No: 000272

Send To: 912 NAVCOM KIT

Subject: RETENTION OF EDO-AIRE  
RADIOS IN EAGLE II  
AIRCRAFT

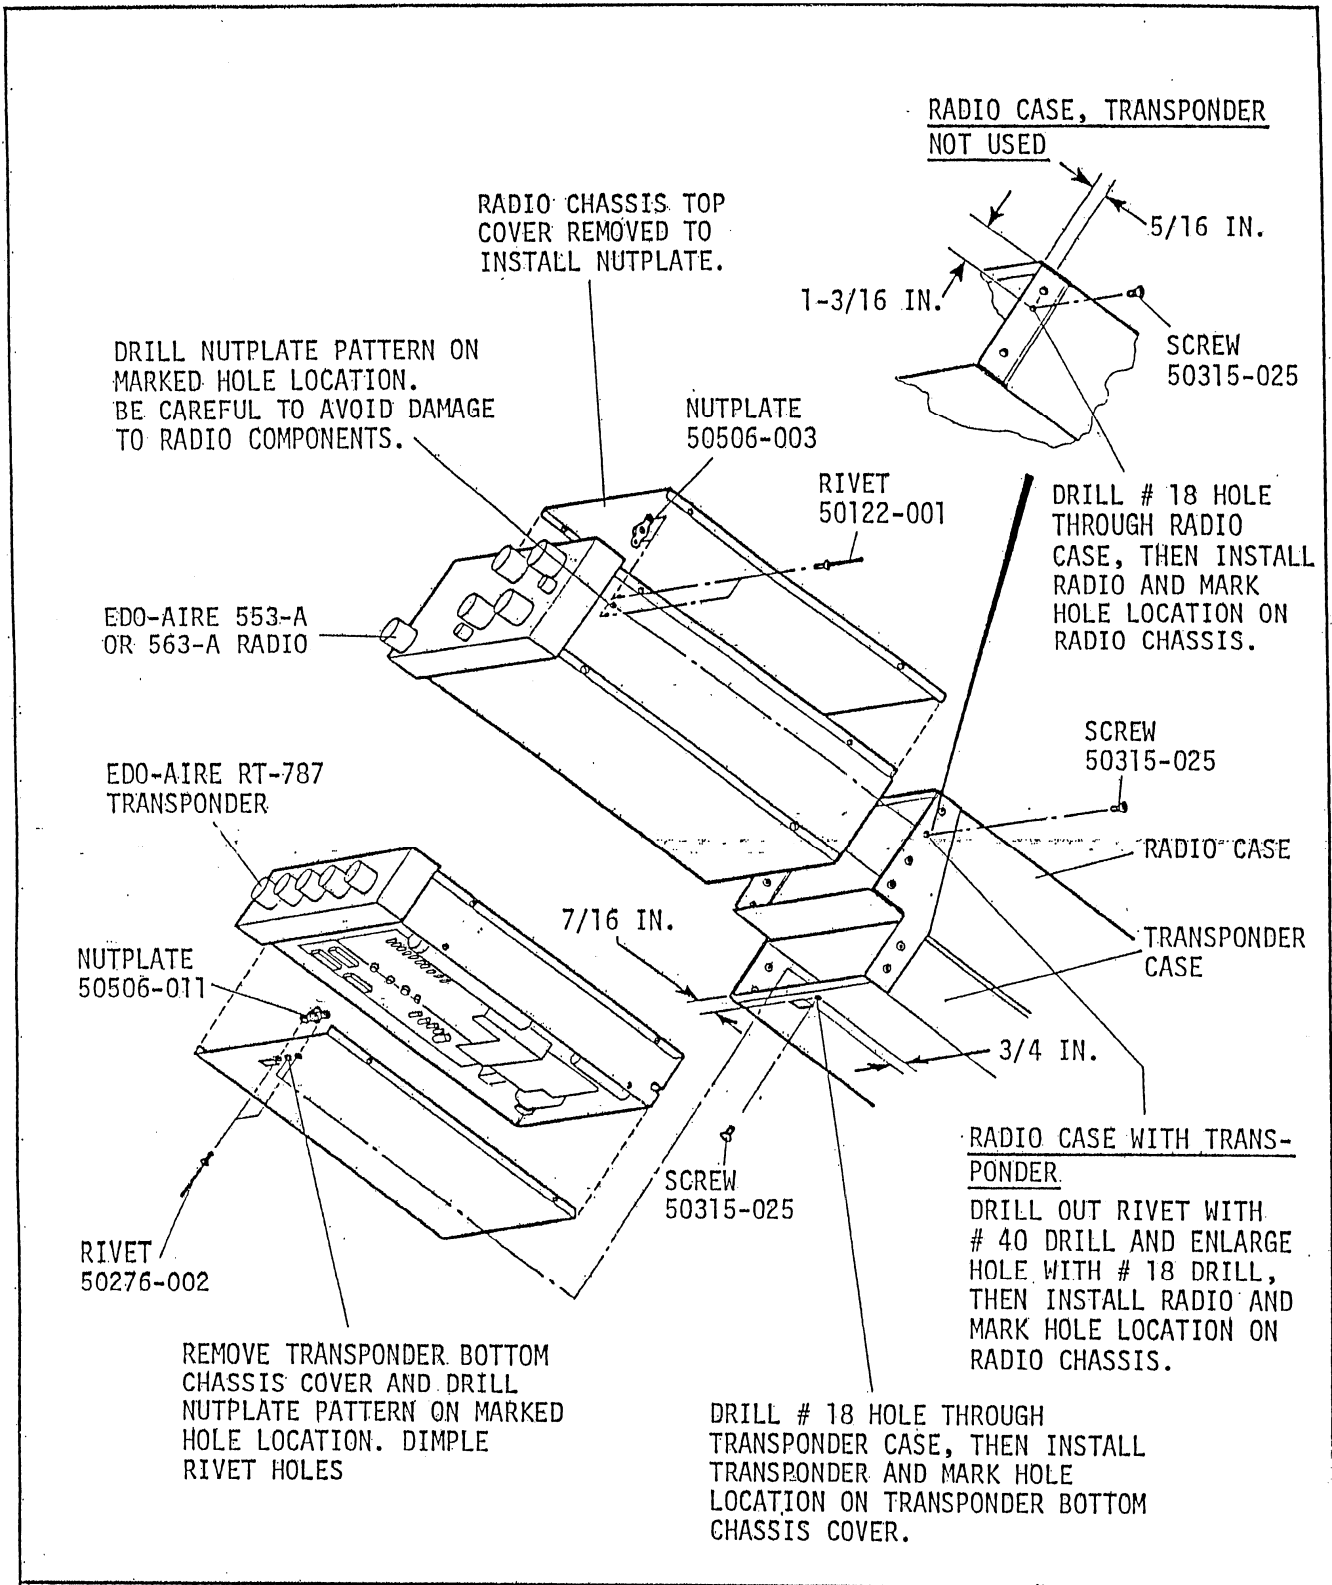
An Eagle builder whose aircraft has the current hook-tab retaining system reported recently that during performance of inverted flight with moderately high negative G-loads his radio came out of the housing with sufficient momentum to injure his hand and to completely penetrate the canopy bubble. The builder is confident that the radio retaining tab was engaged properly and that the tab must have failed, but the radio was lost so this cannot be verified. Failure of the tab is inconsistent with factory testing and aerobatic flight experience.

Although we cannot confirm any inadequacy in the current radio retention system, we want to ensure that there is no possibility of a radio coming free from its support housing during flight, regardless of builder attentiveness in engaging the radio retention system. Therefore, we have added a screw and nutplate retaining system to both the 912 Navcom Kit and the 912-T Transponder Kit. In this system a nutplate is mounted on the inside surface of the radio chassis and a screw extends through the sidewall of the radio support housing to engage the nutplate. The arrangement and installation instructions are shown on the enclosed copy of Engineering Sketch X-90151. The parts for this retention system will be included in all future 912 Kits, and parts are enclosed for retrofit to aircraft whose 912 Kits have already been delivered.

ENCLOSURES: 1 EA 50506-003, 1 EA 50506-011, 2 EA 50122-001, 2 EA 50276-002,  
2 EA 50315-025, 1 EA ENGINEERING SKETCH X-90151
